DOCKETED	
Docket Number:	23-AFC-02
Project Title:	Elmore North Geothermal Project (ENGP)
TN #:	253191
Document Title:	Elmore North Geothermal Project Data Request Response Set 1 (Revised Responses to Data Requests) Notice Letter to ICAPCD
Description:	N/A
Filer:	Lindsey Xayachack
Organization:	Jacobs
Submitter Role:	Applicant Consultant
Submission Date:	11/17/2023 1:29:18 PM
Docketed Date:	11/17/2023

RE: Notification for Permit Application to Construct for the Elmore North Geothermal Project, Imperial County, California

Attachment A: Revised ENGP Well Layout

Figure 1-4R
Project Location
Elmore North Geothermal Project
 Imperial County, California

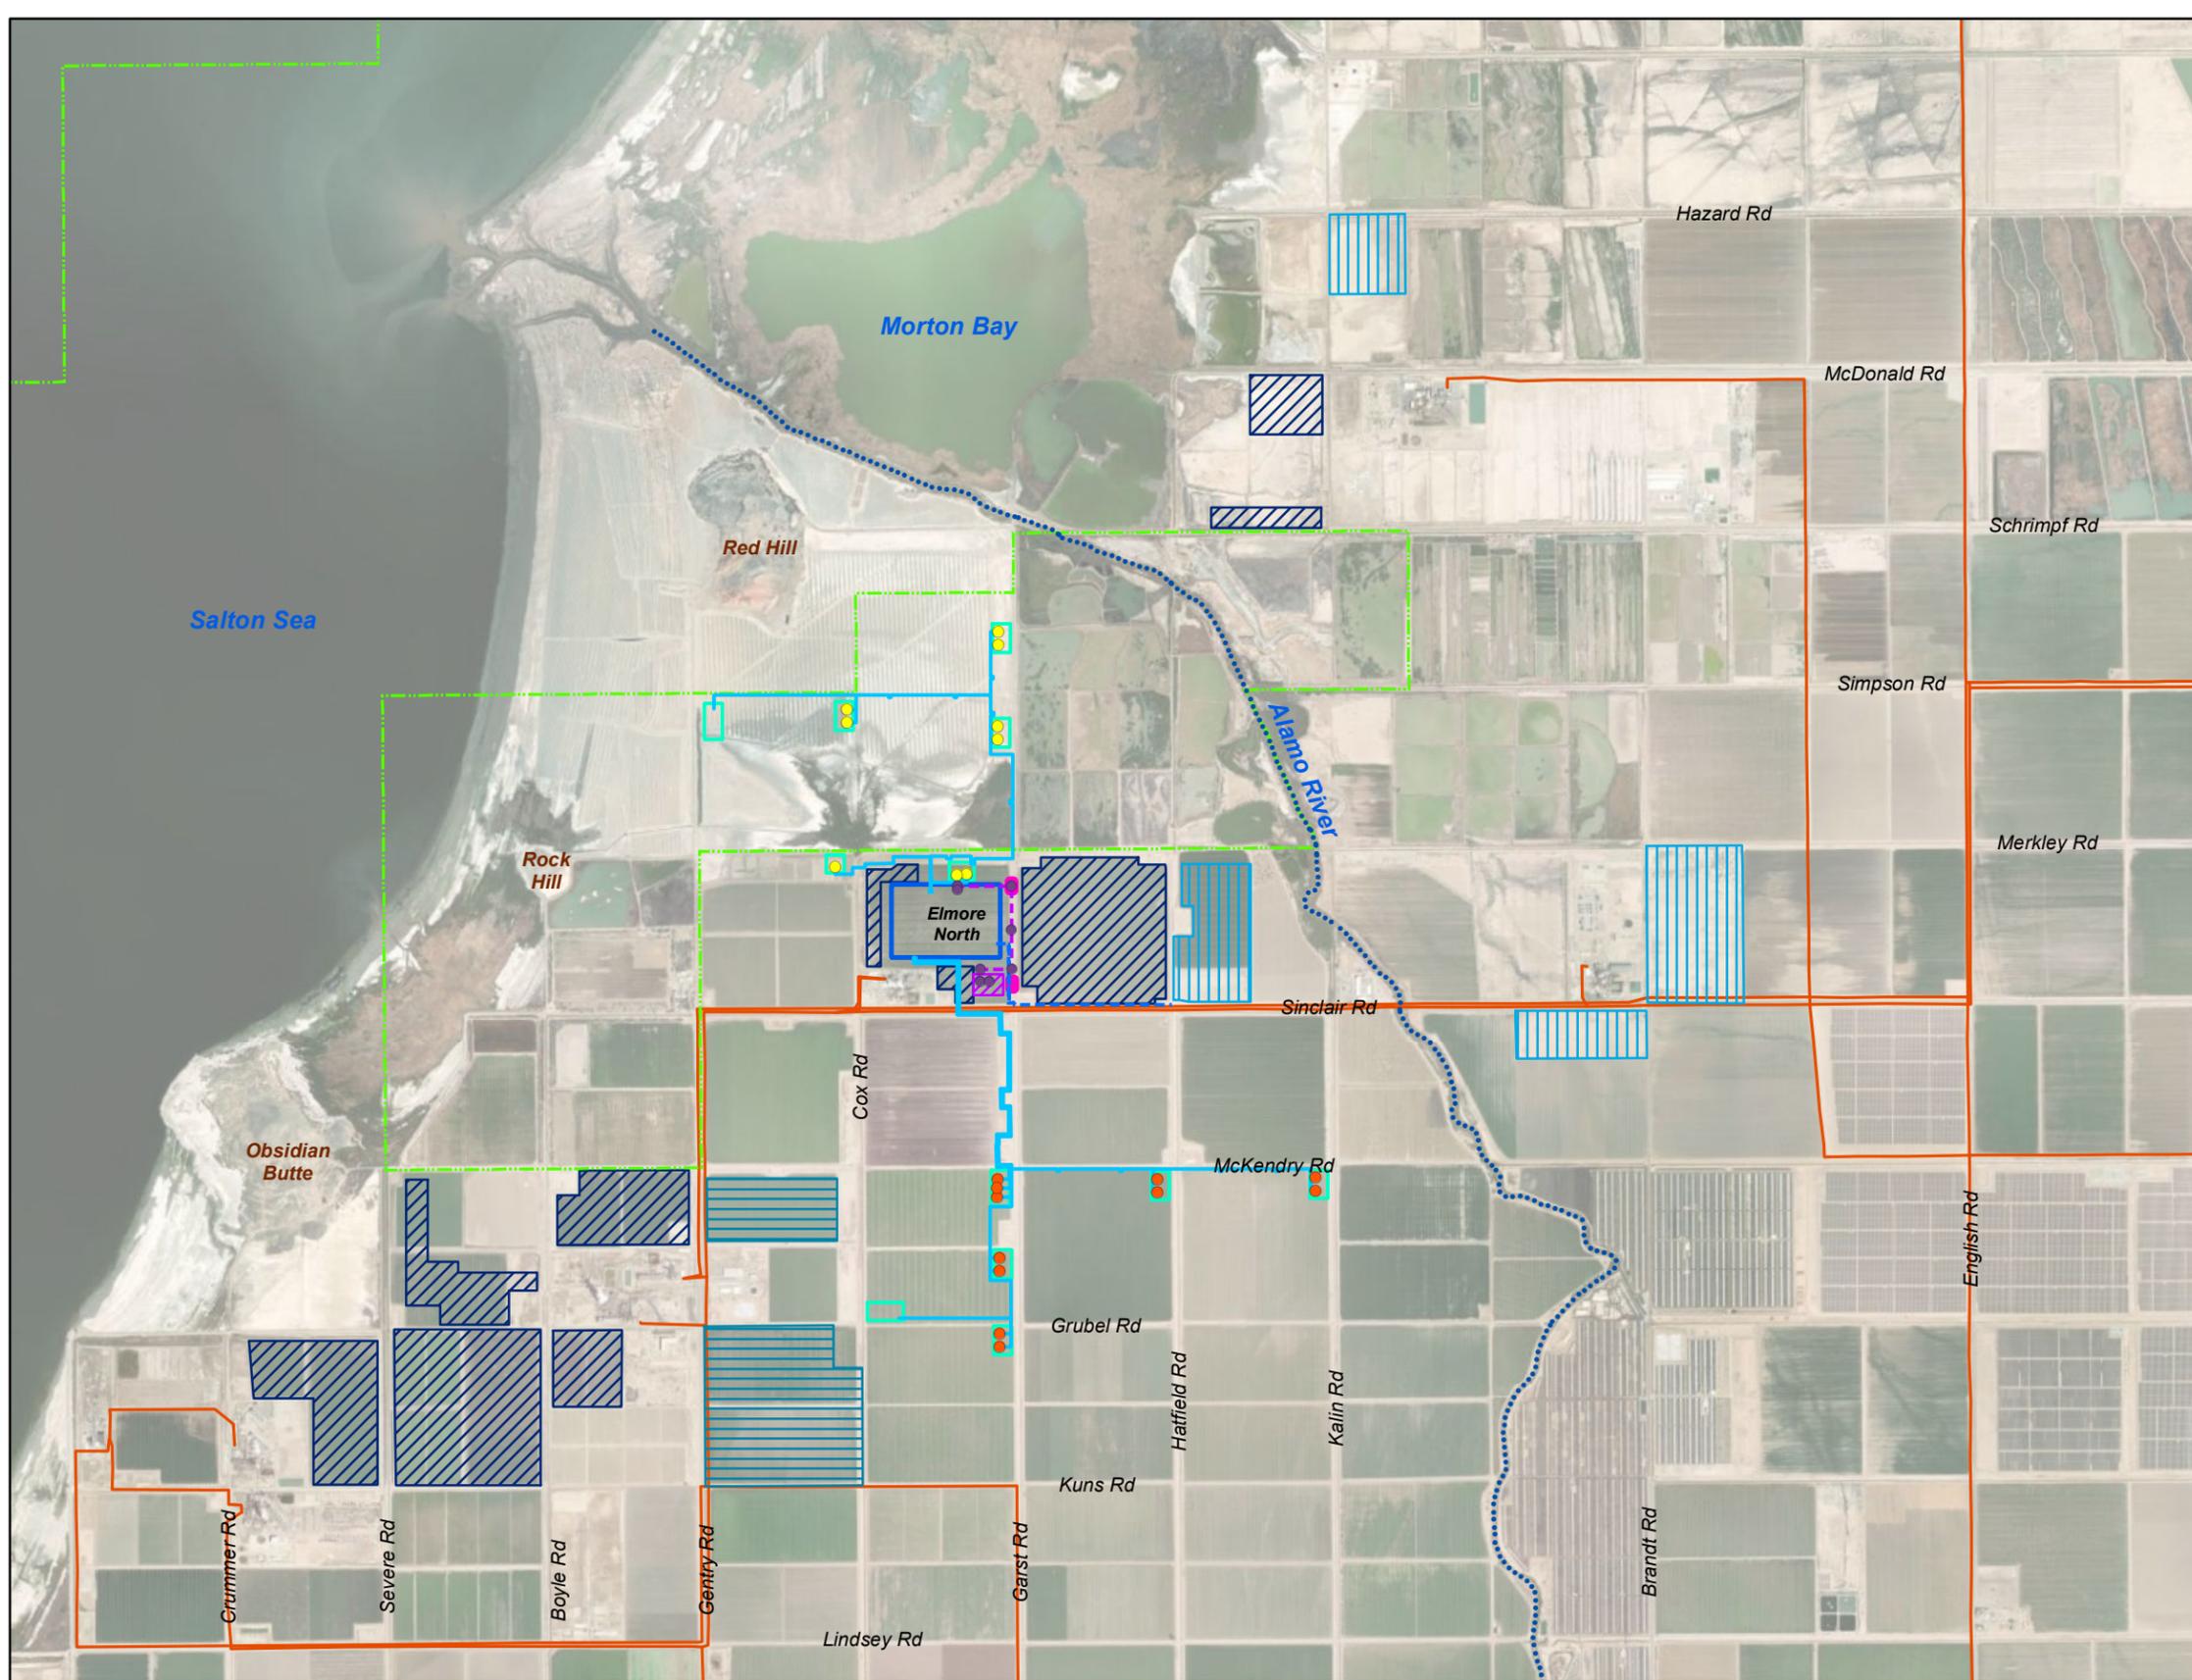
Recent updates have been made to the ENGP design which were not able to be incorporated into the revised analyses submitted on November 10, 2023. Specifically, the location and orientation of the offsite wells and associated well pads have shifted and the number of injection wells was reduced by one. A figure showing the latest ENGP well design layout is included as Attachment A.

These minor layout changes only pertain to offsite emission sources with limited operation and the number of offsite wells has decreased. Therefore, the emission estimates, air quality impact analyses, and health risk assessment modeling submitted to ICAPCD on November 10th are considered to be conservative as well as representative of the updated ENGP design. For these reasons, the Applicant will not be submitting revised analyses for the updated ENGP design.
